ENVIRONMENTAL RE-EVALUATION CONSULTATION

PROJECT TITLE Lowcountry Rapid Transit (LCRT) Project

NEPA Re-Evaluation at 60 Percent Design

August 21, 2024

Figure 3. Proposed Meeting & Lee Station

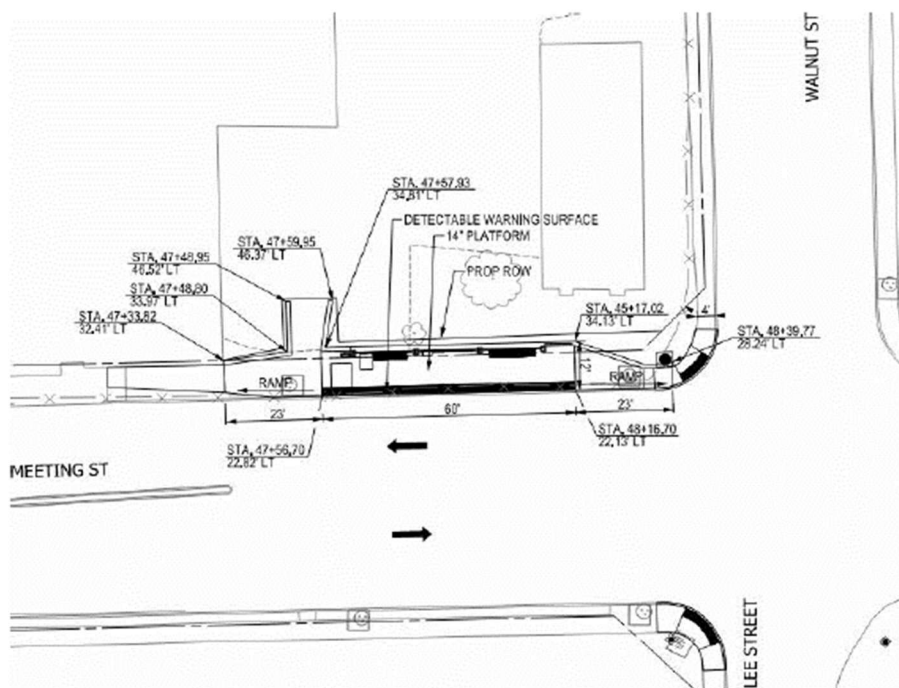
The originally proposed location for this station was at the intersection of Meeting Street and Huger Street/Sheppard Street. The proposed new station location would be located along the eastern edge of an apartment complex parking lot south of the intersection of Meeting Street and Lee Street/Walnut Street, on the west side of Meeting Street (Figure 3). This station is proposed to be relocated south due to constructability and cost concerns at the originally proposed location. This relocation would result in a reduction of 172 linear feet of permanent adverse impacts to New Market Creek, a tidal stream. This relocation would also result in three fewer wetlands impacted for a total reduction of one acre of permanent and 0.55 acre of temporary adverse wetland impacts. A small amount of new permanent ROW would be needed to construct the station. The revised design is within the original project study area (PSA), and there would be no other significant changes in impacts from those described in the DCE at this location.

Figure 4. Proposed King & Hagood Station

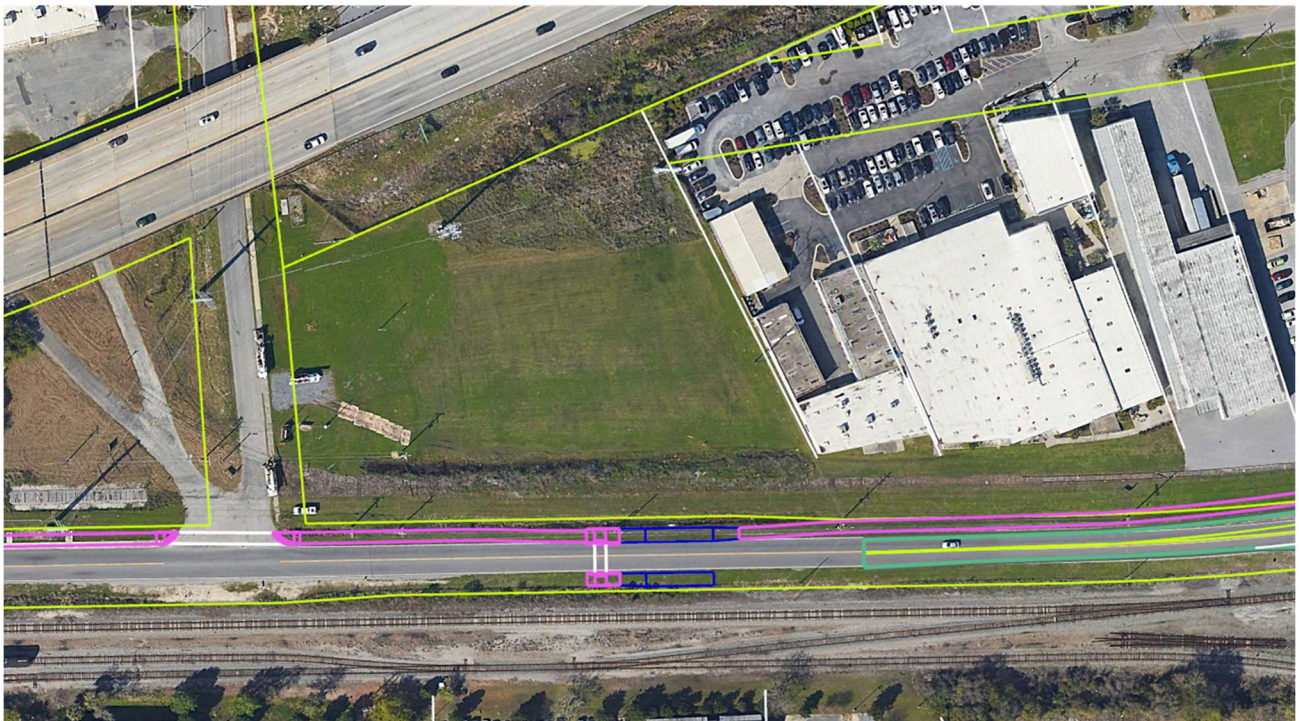
The originally proposed location for this station was at the intersection of King Street Extension and Braswell Street. The proposed new station location would be located partially within a grassy area in existing ROW north of the intersection of King Street Extension and Hagood Street, on the west side of King Street Extension (Figure 4). This station is proposed to be relocated north to accommodate existing Charleston Area Regional Transit Authority ridership and the adjacent Magnolia Development project's proposed permit modifications at Braswell Street. The revised design is within the original PSA, and there would be no significant change in impacts from those described in the DCE at this location.

Figure 5. Proposed Rivers & Helm

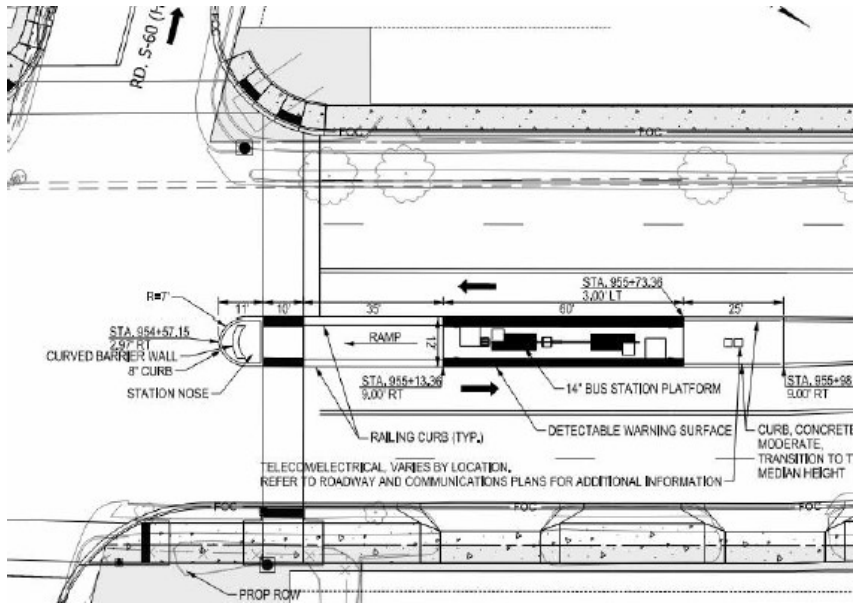
The originally proposed location for this station was at the intersection of Rivers Avenue and Durant Street. The proposed new station location would be located north of the intersection of Rivers Avenue and Helm Avenue, in the center/median of Rivers Avenue (Figure 5). This station is proposed to be relocated south to the Helm Avenue intersection to avoid impacts at the intersection, avoid safety issues related to walls at the station, and minimize coordination with the proposed future bridge project to bridge the railroad crossing here. This relocation also allows for two bus lanes here as opposed to the one bi-directional lane and single-sided two-direction station proposed in the original 30 percent design. The revised design is within the original PSA, and there would be no significant change in impacts from those described in the DCE at this location.

Figure 6. Mall Drive Station at Rivers Avenue and Mall Drive

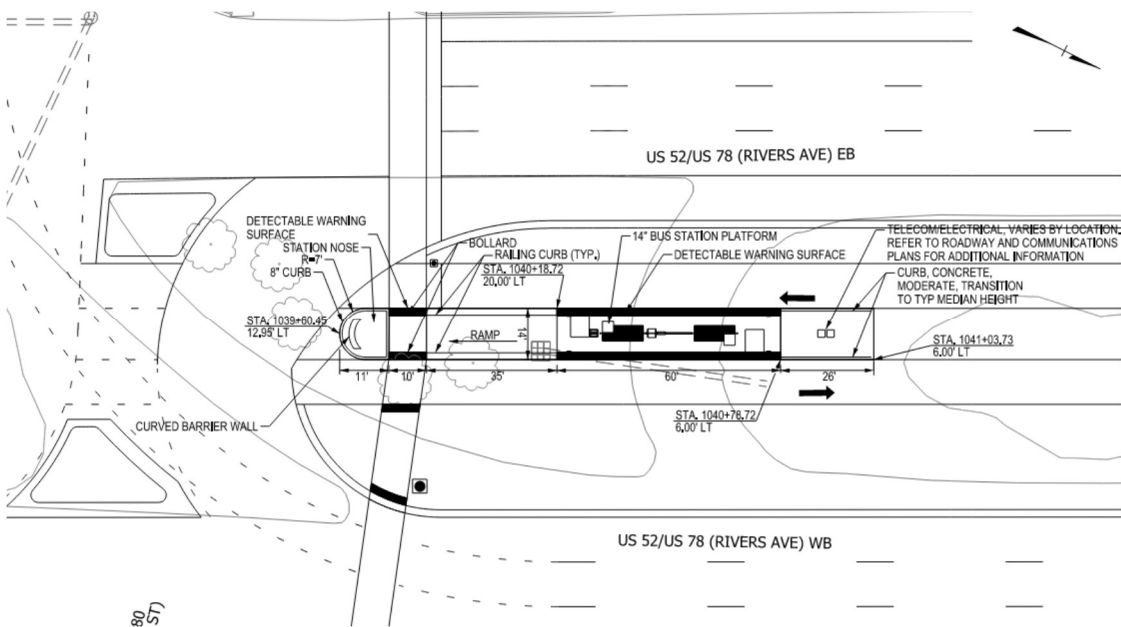
The originally proposed location for this station was at the intersection of Rivers Avenue and Mall Drive. The proposed new station location would be located slightly north of the originally proposed location, in the center/median of Rivers Avenue (Figure 6). This station is proposed to be relocated slightly north to avoid impacts at the intersection and to avoid safety issues related to walls at the station. The revised design is within the original PSA, and there would be no significant change in impacts from those described in the DCE at this location.

Figure 7. Proposed University & BUC Club Station

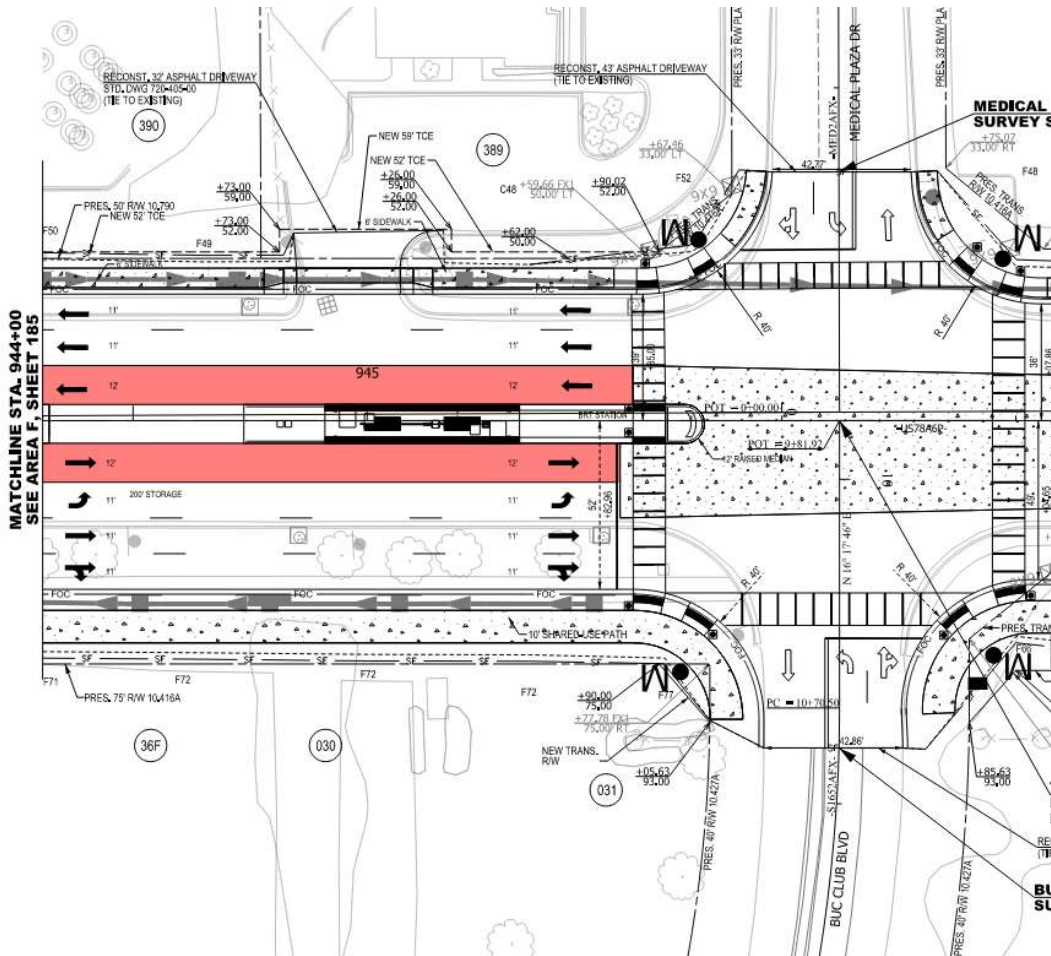
The location of the station has not changed however, the design for this station has been revised from an end-to-end narrow station to provide a standard back-to-back station. The proposed new design was achieved by widening the median from 10 feet to 12 feet in the center/median of Rivers Avenue (Figure 7). This station design is proposed to be changed to provide a safer, standard shelter. The revised design is within the original PSA, and there would be no significant change in impacts from those described in the DCE at this location.

Figure 8. Courtenay & Doughty Station Sidewalk Removal

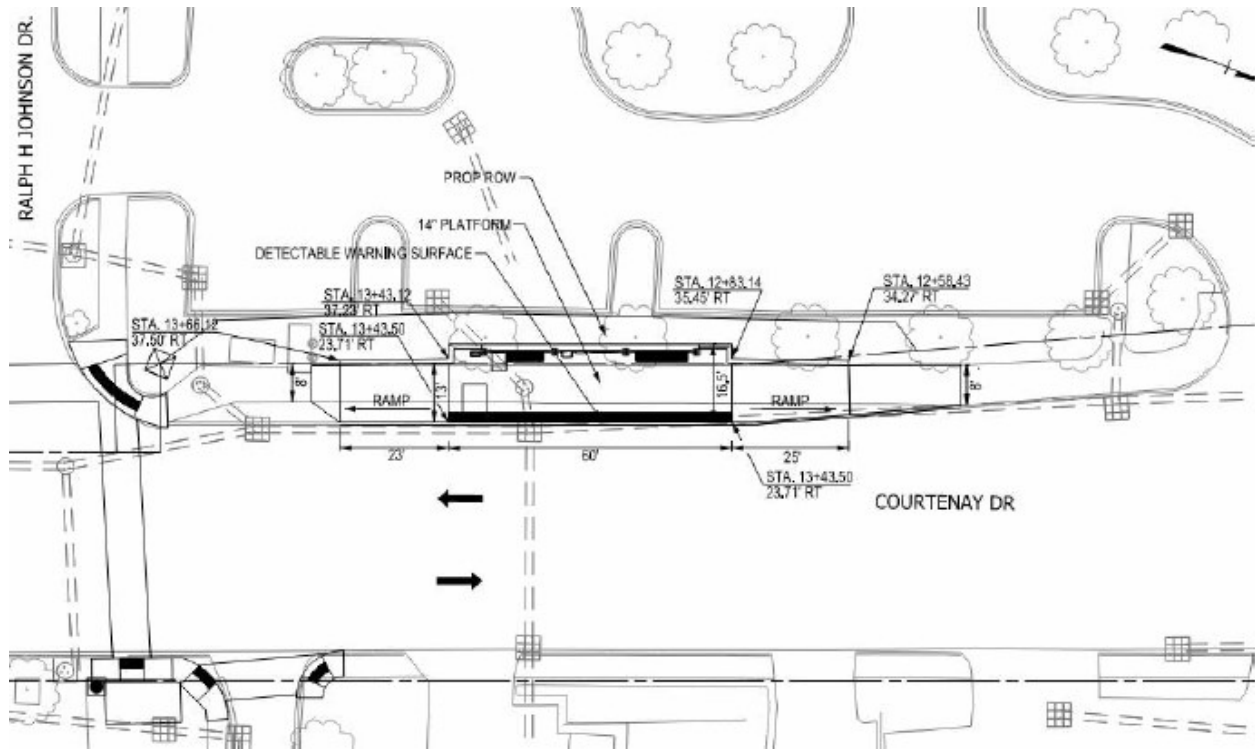
This proposed improvement along the south side of Courtenay Drive would remove the sidewalk behind the station to avoid utility conflicts (Figure 8). The revised design is within the original PSA, and there would be no significant change in impacts from those described in the DCE at this location.

Figure 9. King Street and Calhoun Street Left Turn Lane Removal

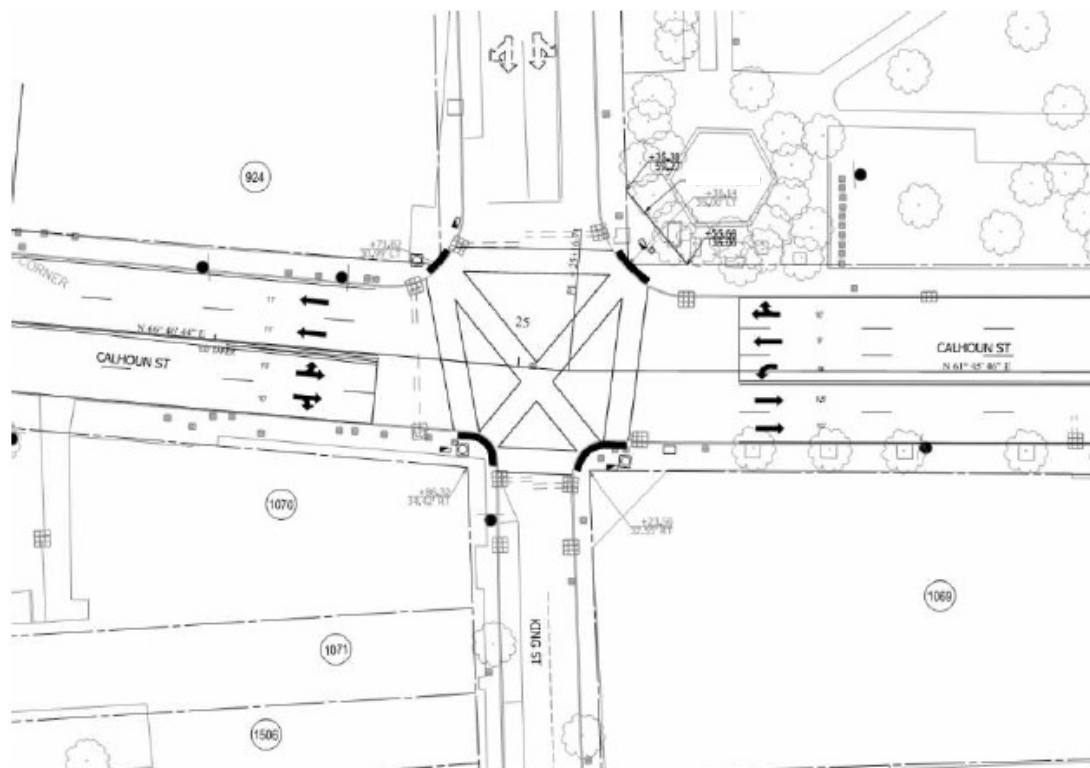
This proposed improvement would result in the removal of the left turn lane from Calhoun Street (eastbound) to King Street (northbound) and the removal of on-street parking along Calhoun Street to the east and west of the intersection (Figure 9). The revised design is within the original PSA, and there would be no significant change in impacts from those described in the DCE at this location.

Figure 10. Rivers Avenue and Melnick Drive Improvements

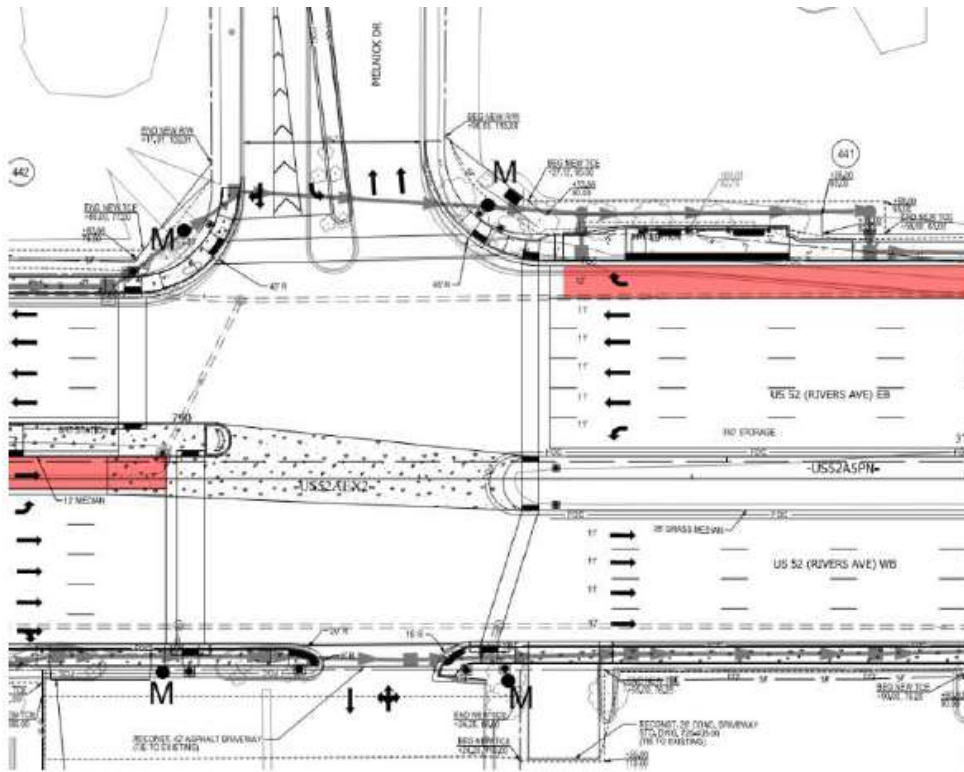
This proposed improvement would provide better gas station driveway access and provide a new angled crosswalk across Rivers Avenue (westbound) (Figure 10). Through consultation with the gas station owner and the South Carolina Department of Transportation (SCDOT), it was determined that the option that maintained left turns with U-turns and provided a slightly angled pedestrian cross walk was the preferred alternative for the intersection. The revised design is within the original PSA, and there would be no significant change in impacts from those described in the DCE at this location.

Figure 7. Rivers Avenue and Otranto Road BRT and Right Turn Lane Improvements

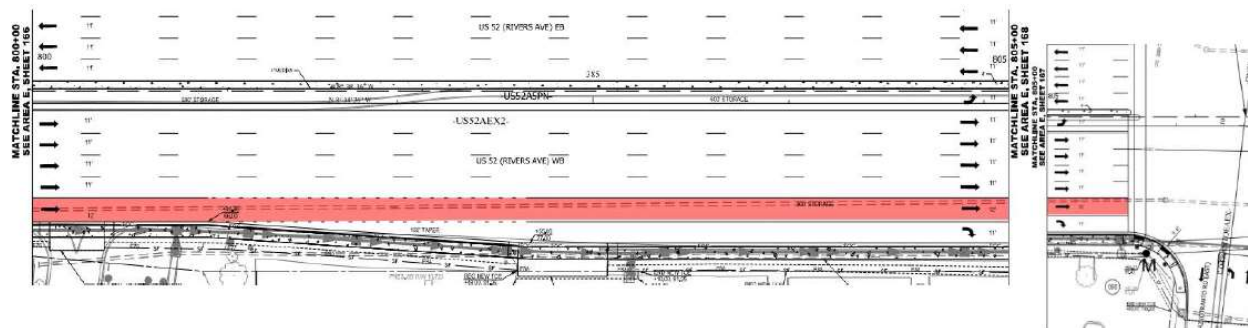
This proposed improvement located along Rivers Avenue (westbound) at Otranto Road would include the flipping of the bus lane and the right turn lane to reduce conflicts (Figure 11). The revised design is within the original PSA, and there would be no significant change in impacts from those described in the DCE at this location.

Figure 8. University Boulevard and Fernwood Drive BRT and Right Turn Lane Improvements

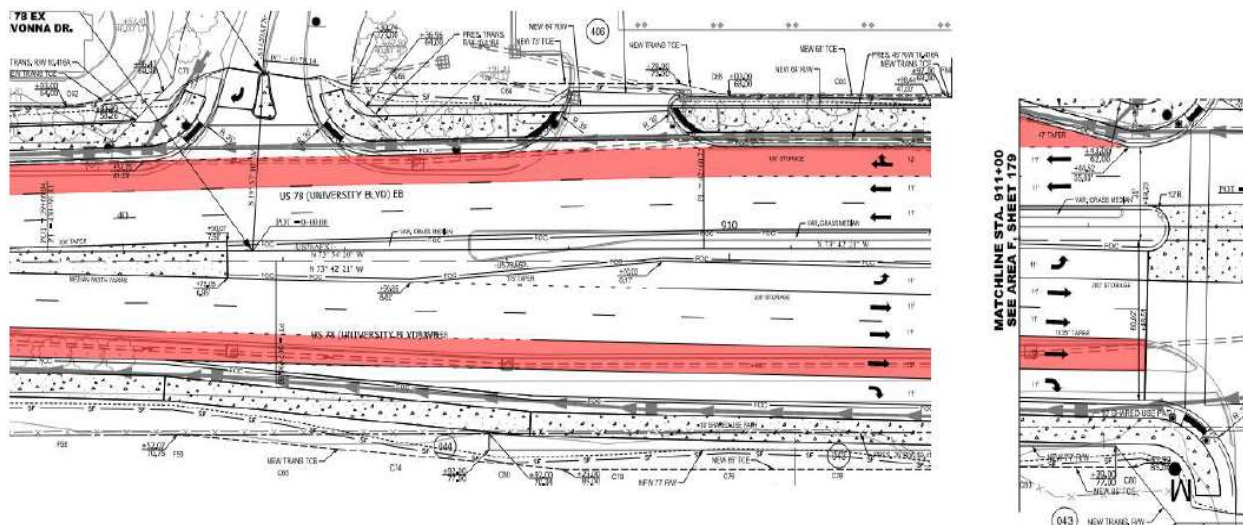
This proposed improvement located along University Boulevard (eastbound and westbound) at Fernwood Drive would include the flipping of the bus lane and right turn lane to reduce conflicts (Figure 12). The revised design is within the original PSA, and there would be no significant change in impacts from those described in the DCE at this location.
